Preliminary Consultation
MONTGOMERY COUNTY HISTORIC PRESERVATION COMMISSION
STAFF REPORT

Address:	6950 Carroll Ave., Takoma Park	Meeting Date:	12/7/2022
Resource:	Outstanding Resource Takoma Park Historic District	Report Date:	11/30/2022
Applicant:	Bank of America	Public Notice:	11/23/2022
Review:	Prelim	Staff:	Dan Bruechert
Proposal:	Fenestration Alteration, HVAC Installation and Associated Screening, and Building Addition

03 Proposed North Elevation
Scale: 1/8" = 1'-0"

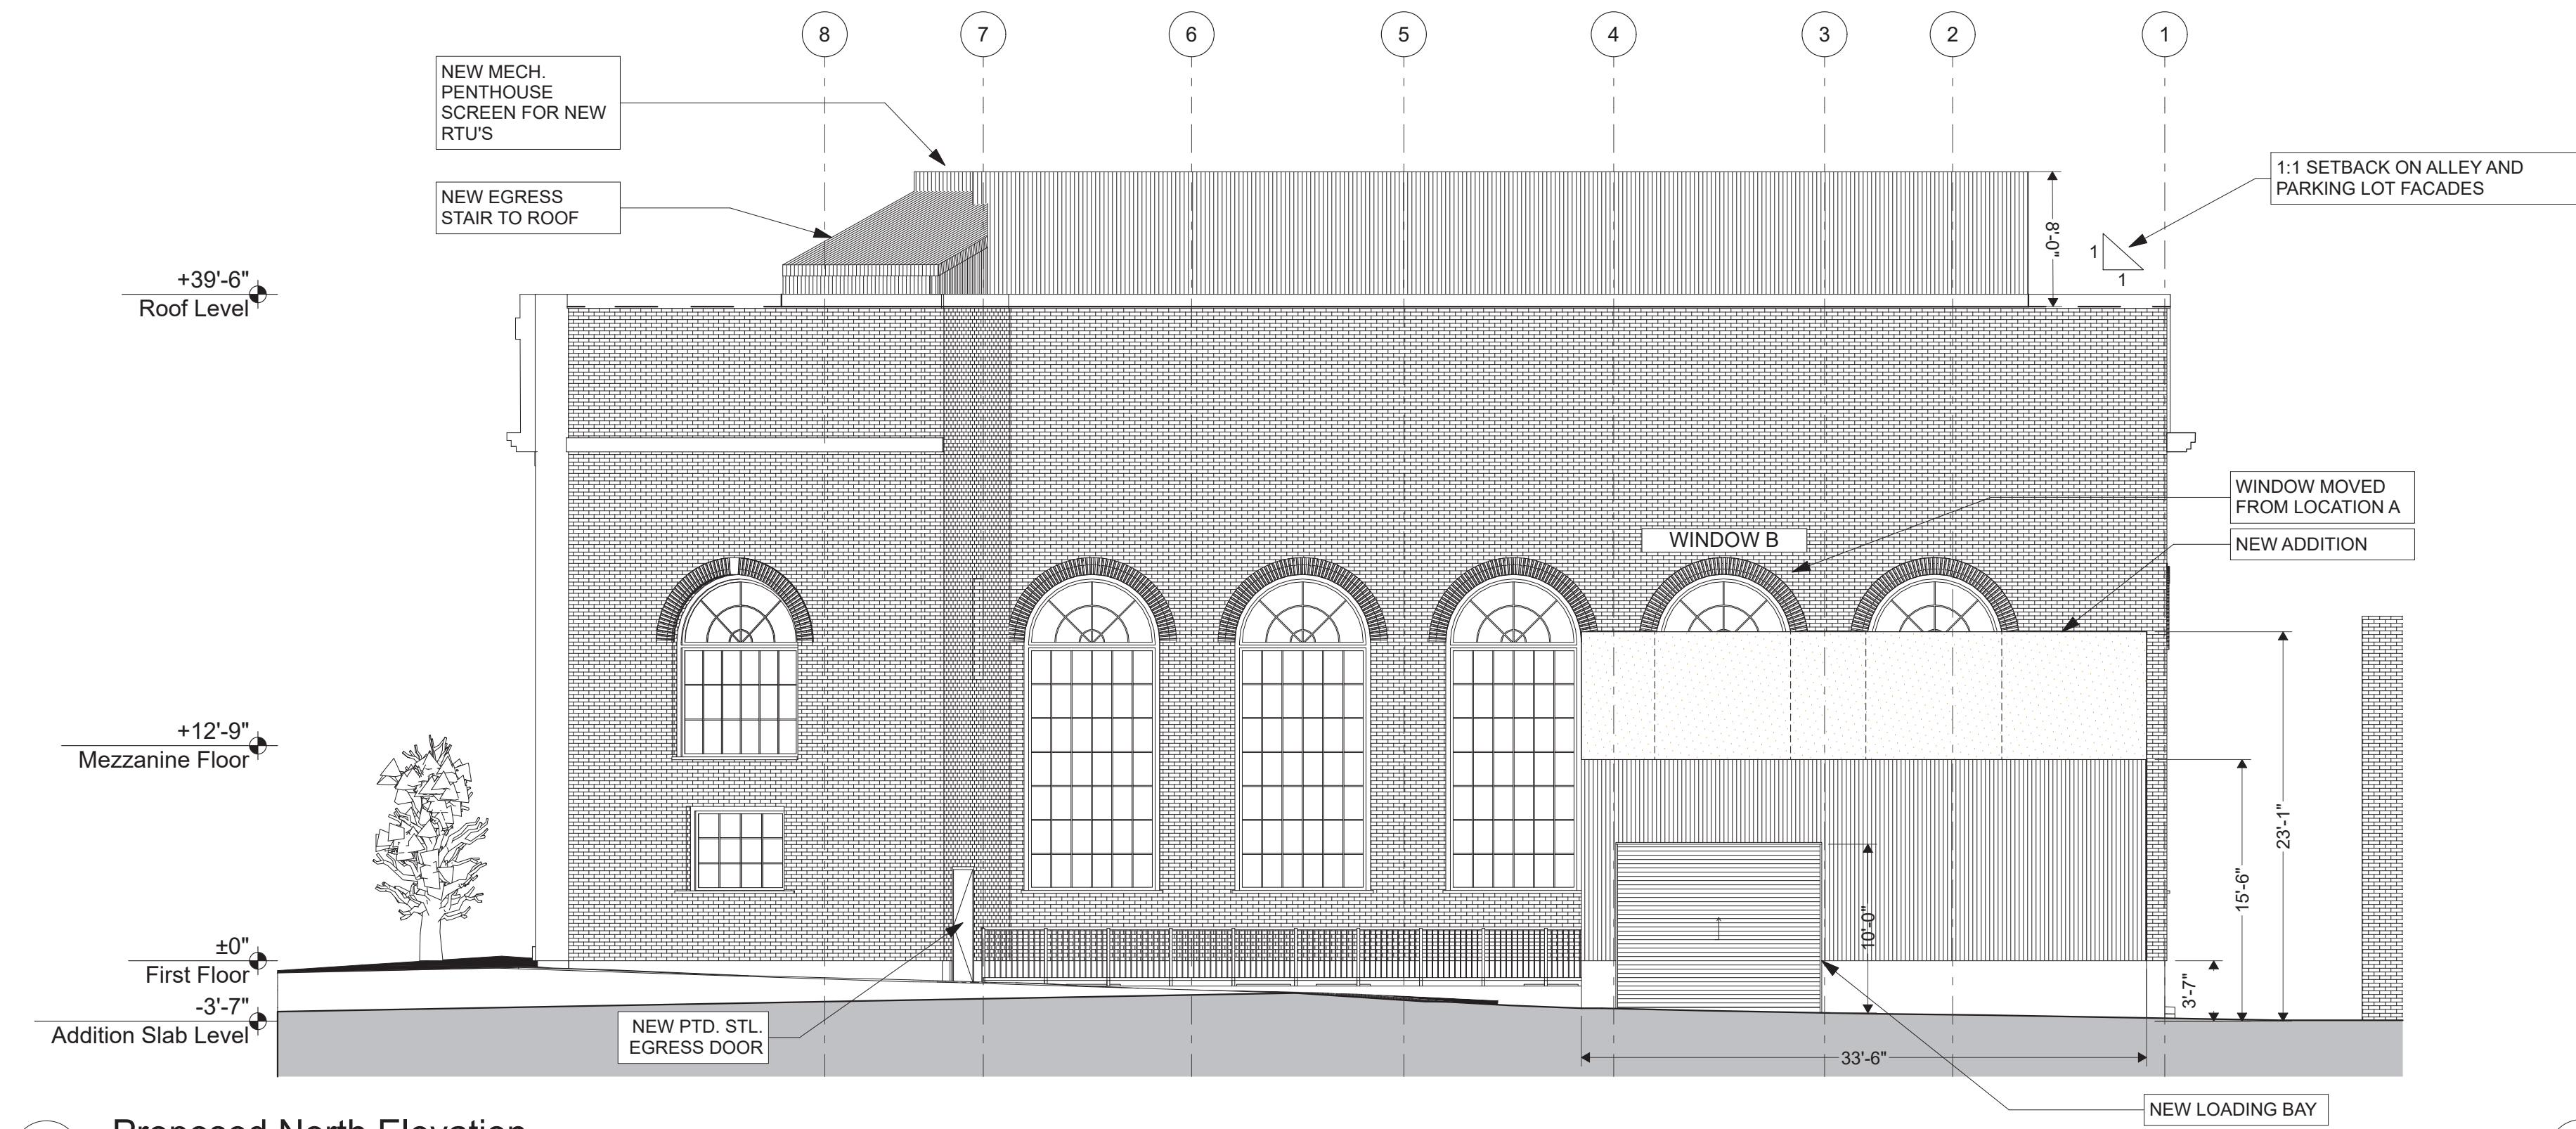
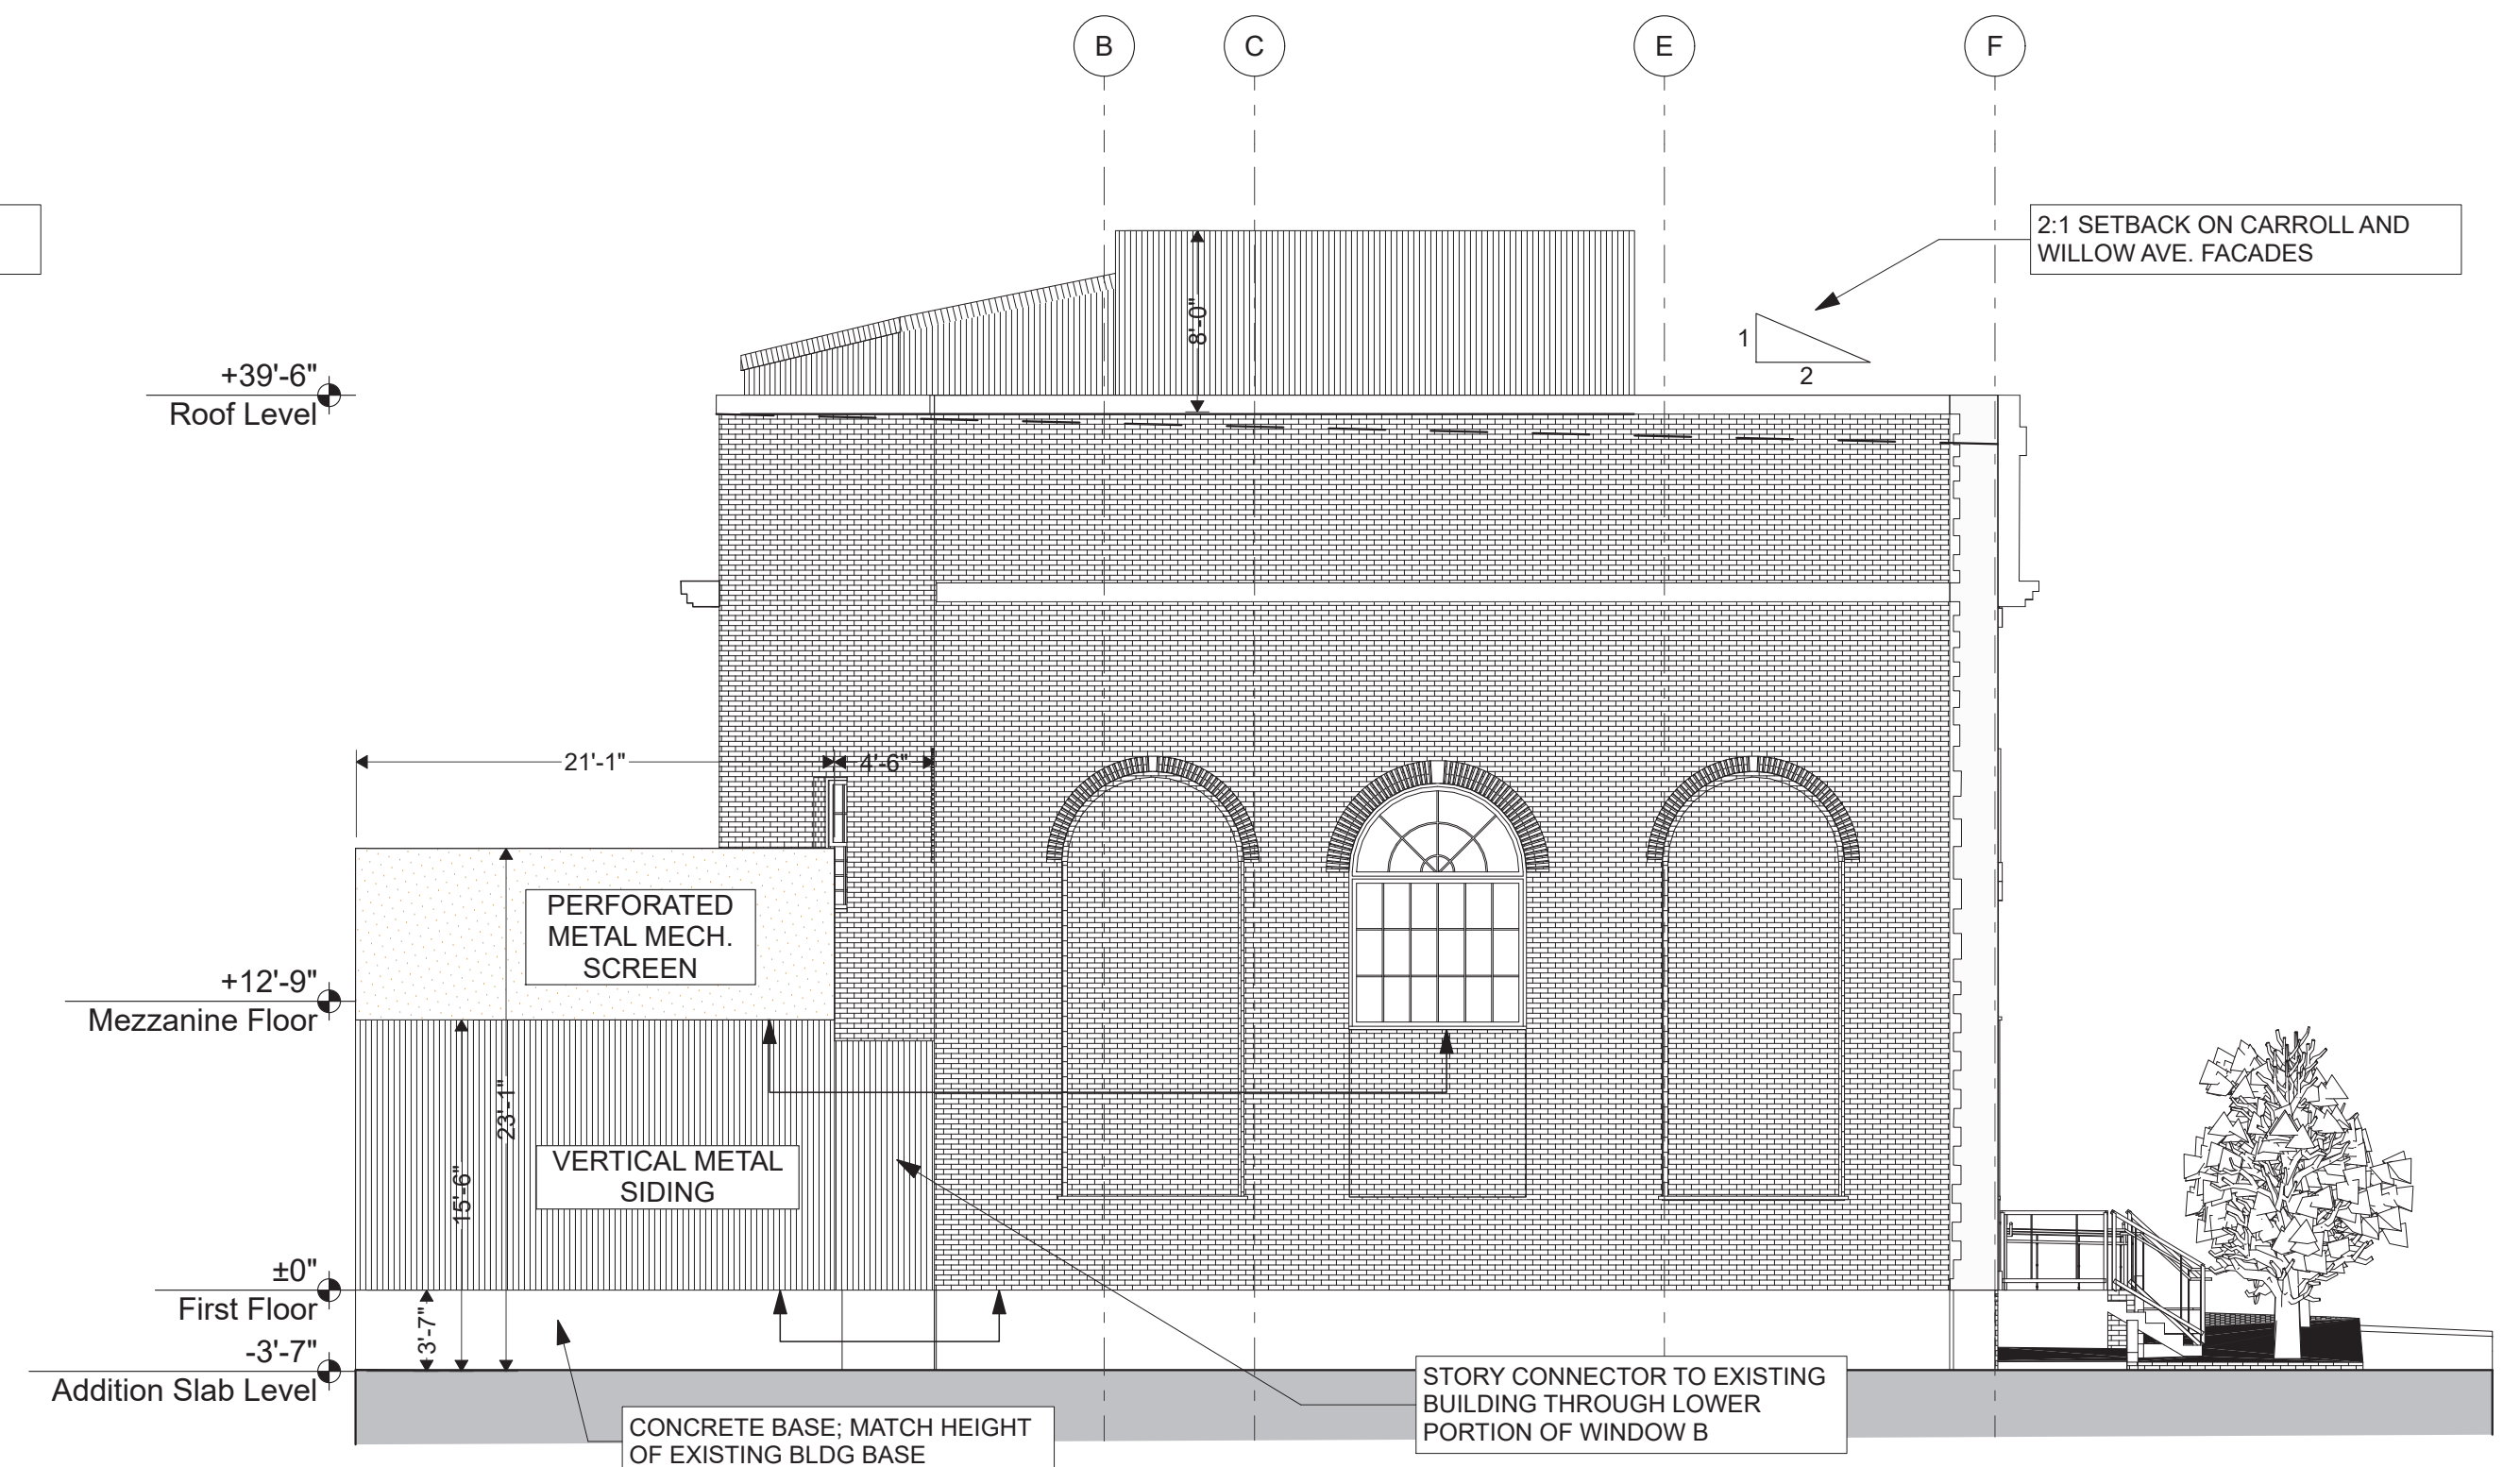
The applicant proposes to maintain the existing, ADA-compatible, front entrance. However, a single entrance is not sufficient for the needs of the building program or to satisfy current building codes. The applicant proposes to install a new entrance from the parking lot on the north elevation in a location not visible from the public right-of-way. The proposed door will be a solid, painted steel door.

Staff finds the proposed door will only be visible from the parking lot and not visible from the public right-of-way as recommended by the *Design Guidelines*. Additionally, the entrance is proposed for a section of blank wall, so no historic openings will be impacted by the new door. Staff notes the applicants reviewed the HPC's comments from the January 2022 Preliminary Consultation (linked above) and purposefully avoided installing the door in a location that would require removing a historic window. Staff finds the proposed door will be visible as a utilitarian feature that does not detract from the architectural significance of the historic building.

Staff requests feedback from the HPC regarding the appropriateness of the proposed door location, material, and design.

1. PERFORATED MECHANICAL SCREENS

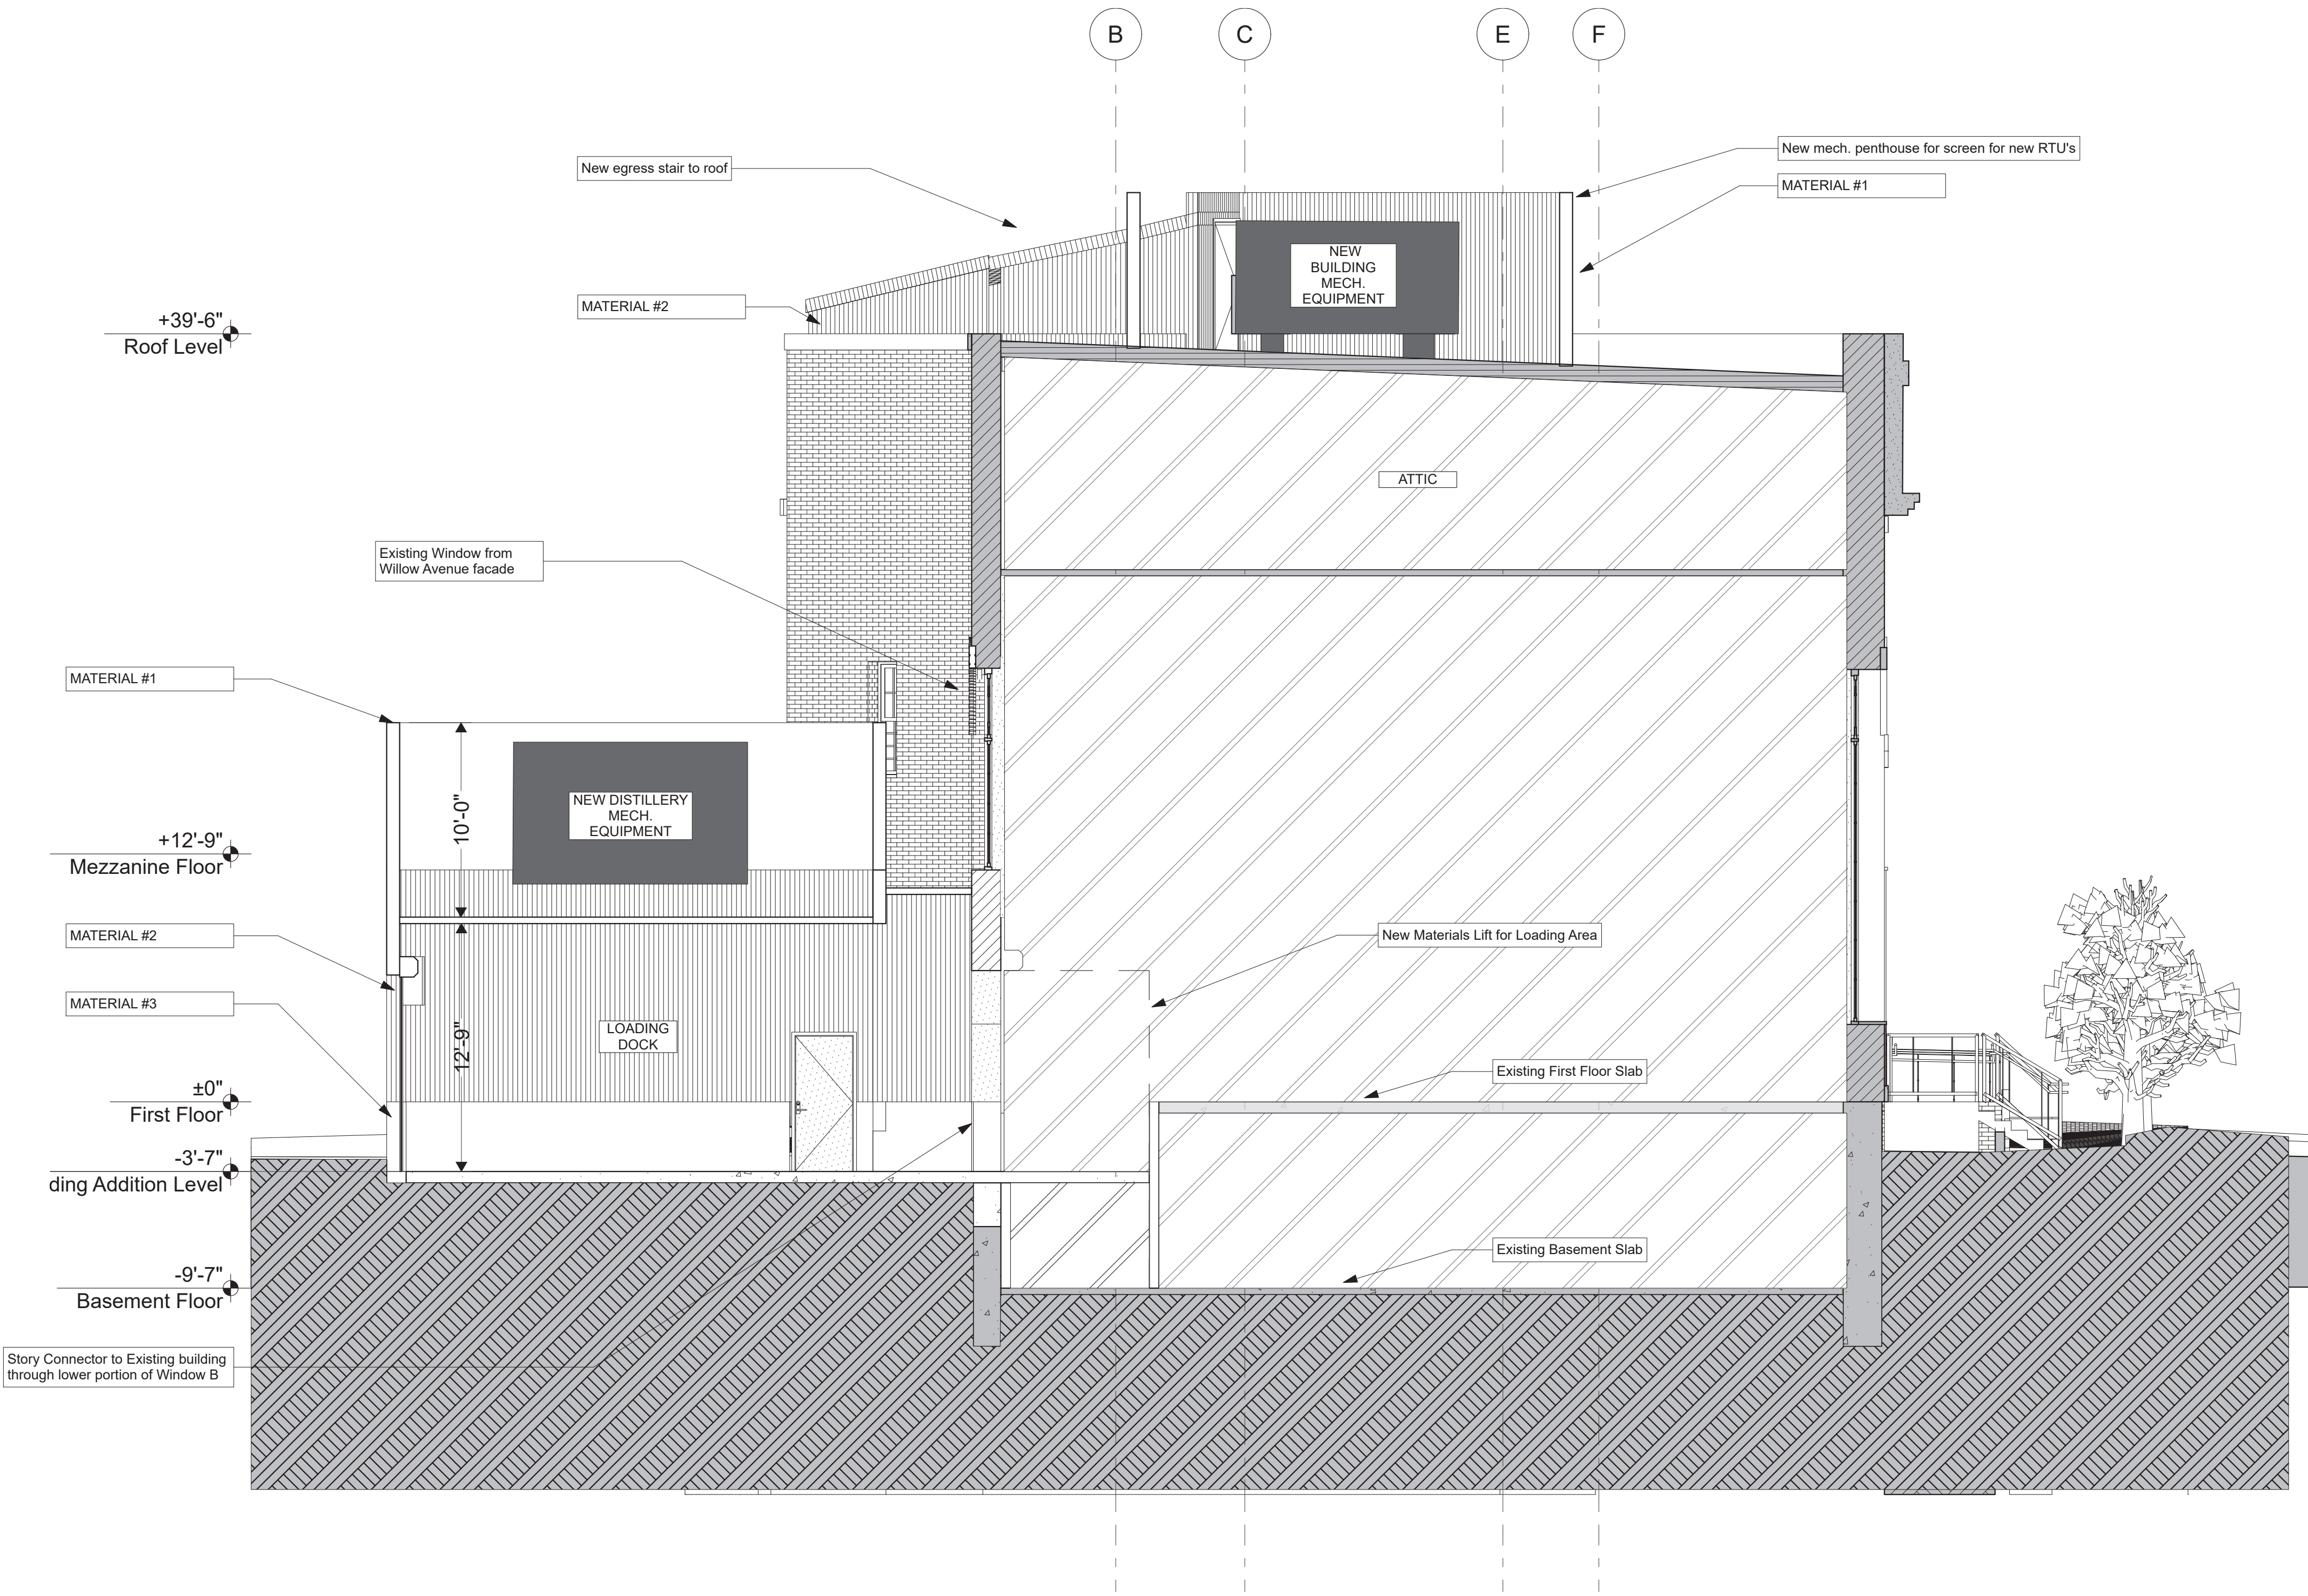
Staff is concerned about the compatibility of the proposed perforated mechanical screen. The highly reflective metal surface will likely detract from the dull masonry building material. A metal screen with a matte finish may be more compatible. Staff requests feedback from the HPC regarding the appropriateness of the proposed mechanical screening material, height, and location. Additionally, Staff also requests feedback regarding the placement of the mechanical system on the roof.

As with the proposed mechanical screening, Staff remains uncertain if the vertical metal panels are an appropriate material for an addition to the subject property. The shiny metal finishes highly contrast with the masonry building. However, Staff also finds that the metal paneling is consistent with the industrial character and function of the proposed addition and recognizes that this material and its visual contrast are sufficiently differentiated under Standard 9. Staff finds that a finish that is either consistent with a baked enamel finish or a masonry exterior would be appropriate. For example, the neighboring property to the west constructed a mechanical addition to the rear and covered it in brick to match the rest of the building exterior (this addition is the approximate size of the one proposed). Staff finds that the neighboring building addition blends into the original construction and does not draw visual attention. Staff requests HPC feedback on:
